**APPEAL TO
PLANNING COMMISSION
PARKLAND REQUIREMENT
REVIEW SHEET**

CASE NUMBER: SP-2020-0419C **Parks Board:** September 14, 2021
Planning Commission: September 28, 2021

CASE NAME: Koenig Lane Multifamily

Appeal of the Parkland Dedication Land Requirements for Koenig Multifamily (SP-2020-0419C)

FIGURE A - CURRENT PROPOSED SITE PLAN / PARK PLAN

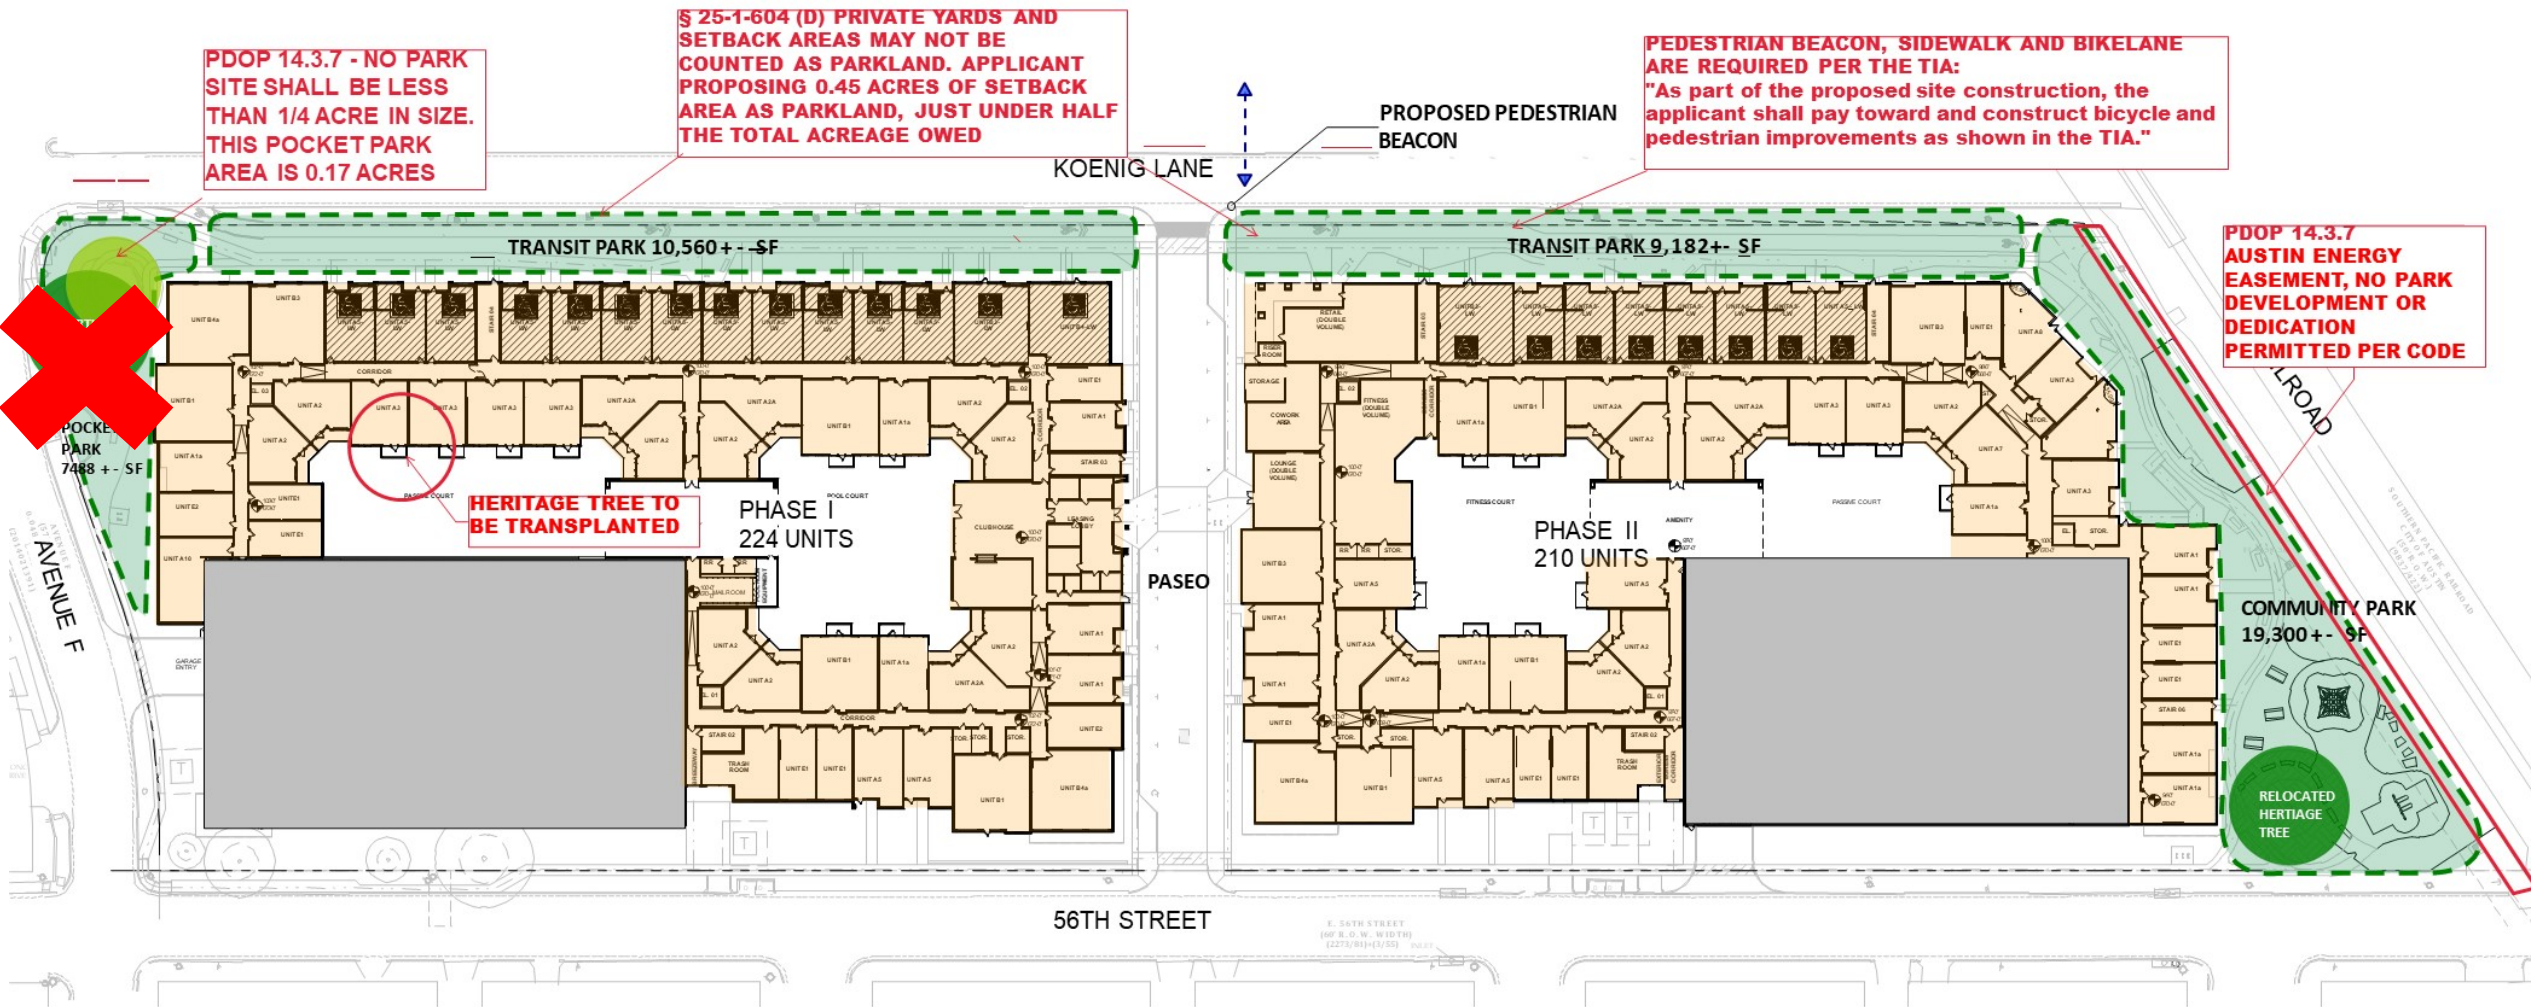
Given these factors, we believe it is appropriate to approach the Project with the dual goals of providing on-site parkland access in a way that ensures full affordability and Project viability. To that end, we have proposed over one acre of parkland across the site, with two larger areas on the eastern and western edges of the site that connect across the front of the site ("Applicant Compromise Plan") (Exhibit 1).

This Applicant Compromise Plan includes a wide variety of public amenities including bicycle and pedestrian pathways, a dog park and wash station, natural flower and stone garden, preservation of an existing heritage tree as well as a variety of planted shade trees, stationary fitness stations, benches, tables, and children playscapes. Under this proposal, the parkland area constitutes 15.27 percent of the site, slightly more than the maximum 15 percent that the Land Development Code allows PARD to require. And, with the additional uncredited easement area that the applicant helped secure (described above), the effective total parkland area represents over 16 percent of the site.

PARD OPTION 3

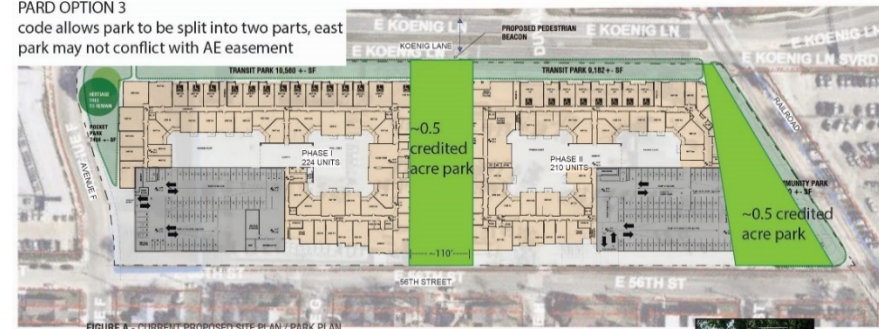
Consolidate park on west side of the building to preserve existing trees and avoid conflict with AE easement

PARD OPTION 2

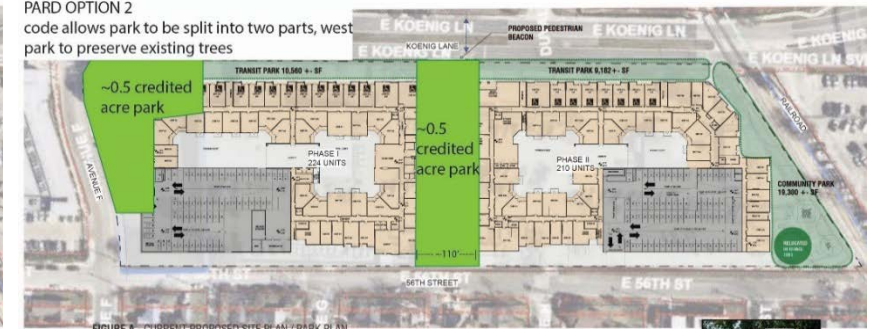
code allows park to be split into two parts, west park to preserve existing trees

Exhibit 2: PARD Western Consolidation Plan

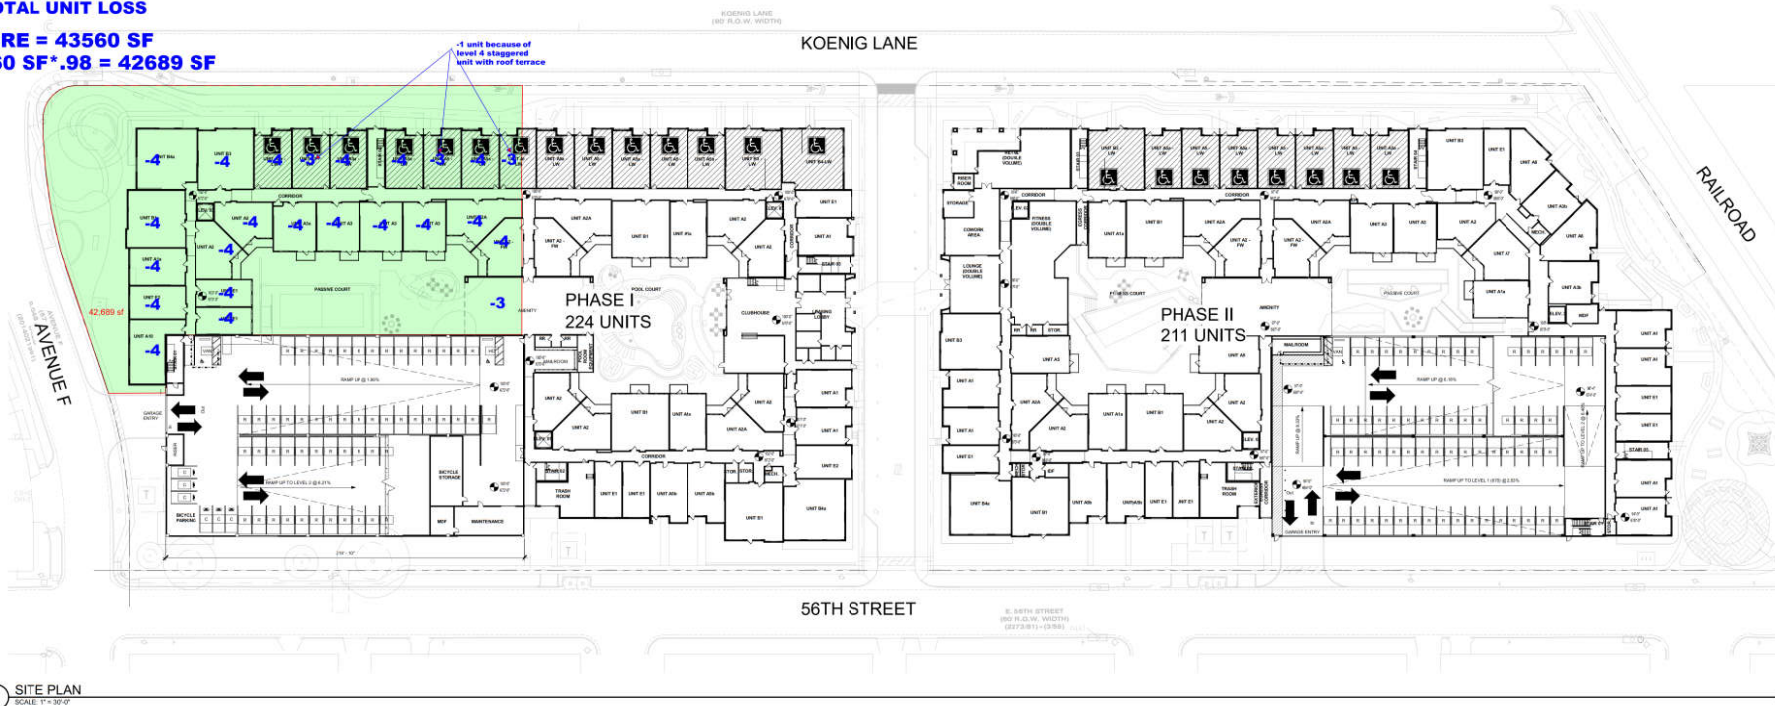
82 TYPICAL UNIT LOSS
10 AMFI UNIT LOSS (AFFORDABLE)
92 TOTAL UNIT LOSS
1 ACRE = 43560 SF
43560 SF * .98 = 42689 SF

FIGURE 'A' - BUILDING IMPACT DIAGRAM

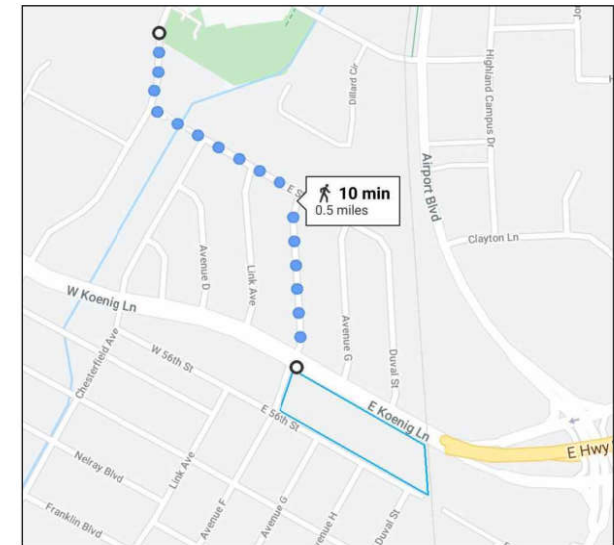
15% CONSOLIDATED PARKLAND BUILDING / UNITS IMPACTED
